KIRK[®] Release Notes
KIRK[®] 6020, KIRK[®] 7010 and KIRK[®] 7020

Firmware Version PCS 07Aa
Q4/2010

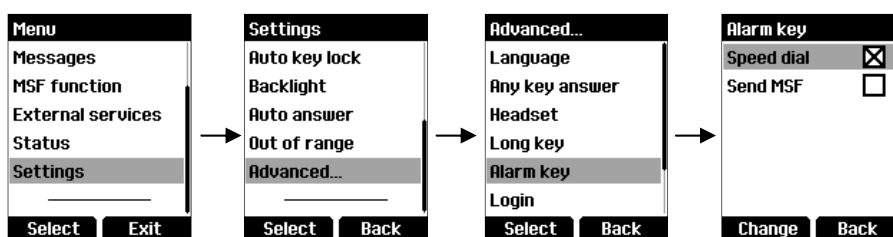
- Portuguese language added.
- Added support for broadcast messaging¹. The messaging format now includes icons.
- During an active voice call, the alert tones of received messages are attenuated by 30dB.
- The speaker gain, when in loudspeaking mode, has been raised by 12dB.
- Ringer tone 2 has been replaced by a low-frequency higher volume “digital” ringer tone.
- Ringer tone 3 has been replaced by a high-frequency higher volume “digital” ringer tone.
- The built-in wired headset amplifier² can be configured using the handset menu, see screen dumps below. The selectable amplification range spans from -12dB to +18dB.

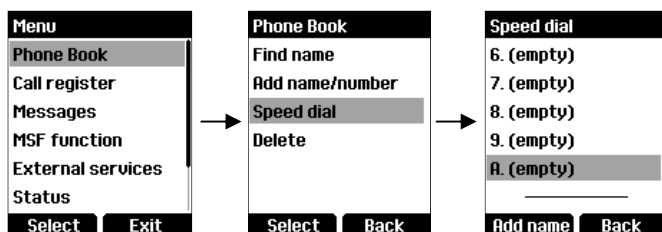
- An entry in the phonebook can be assigned to a long key press on the alarm key. First the alarm key must be configured to use speed dial, see below.

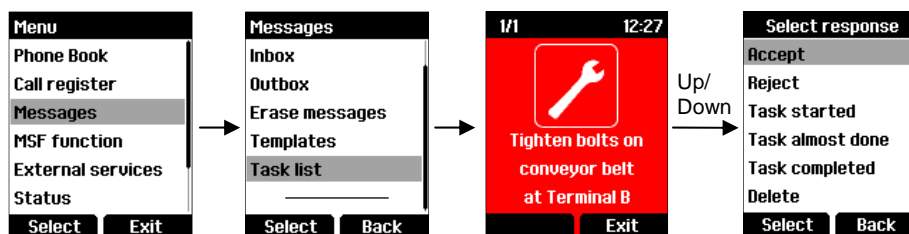
Then speed dial entry “A” must be assigned by selecting Add name:
